HYDROLOGY D17/D54 CASCO INDUSTRIAL DEVELOPMENT

RE: GRADING & DRAINAGE PLAN FOR CASCO INDUSTRIAL DEVELOPMENT
(D-17/D54) RECEIVED NOVEMBER 21, 1984

RE: REVISED DRAINAGE PLAN FOR CASCO INDUSTRIAL DEVELOPMENT
(D-17/D54) RECEIVED JANUARY 16, 1985

TITLE: JOURNAL CENTER PHASE III
SNAPROLL STREET

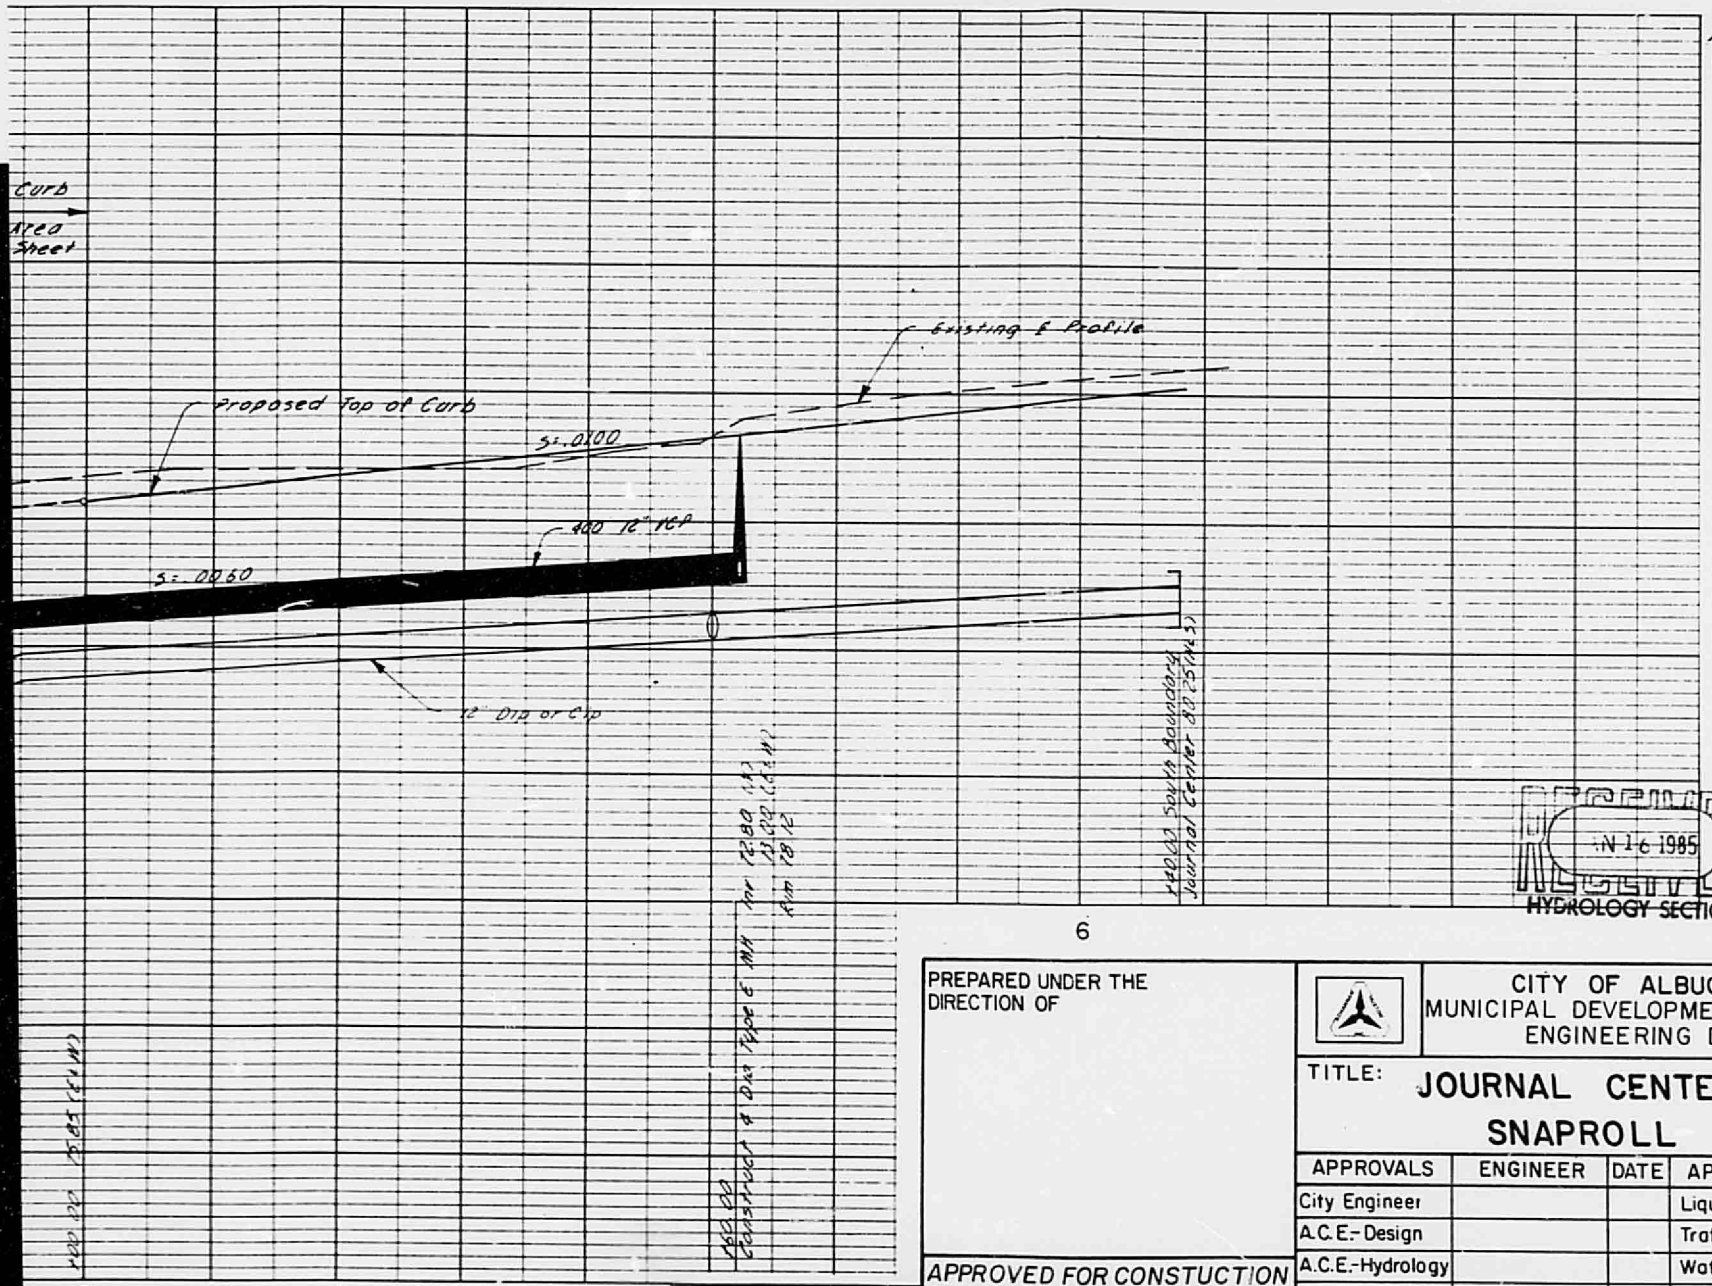
1. In the pre-design recap, it was identified that the grade for Snaproll Street would be investigated. This has not been addressed.
2. Since there is an existing concrete lined channel with inlet into the North Diversion Channel, why cannot the inlet be utilized by the development of this site? Elevation differences do not appear to be significant.

1. The current Drainage Management Plan for the Journal Center indicates that Snaproll Street N.E. will drain north to Masthead Street N.E. and then into the North Pino Arroyo via an earthen channel. Based upon this trend, the CASCO site will not be adversely affected by any drainage from the Journal Center. In addition, the grading of the CASCO site matches existing grades along the north property line and therefore satisfies that criterion. The predominant trend in this area is that in which drainage flows to the Pino Arroyo. Also, I have spoken with Mr. James Topmiller, Bohannan-Huston, and have learned that Snaproll Street may never be built. Mr. Topmiller has also provided me with a copy of the preliminary grades for Snaproll Street. This drawing appears to be in a preliminary stage. Once this design is completed for approval, the south end of Snaproll Street should be raised slightly to match existing grade. I foresee no problems in doing this.
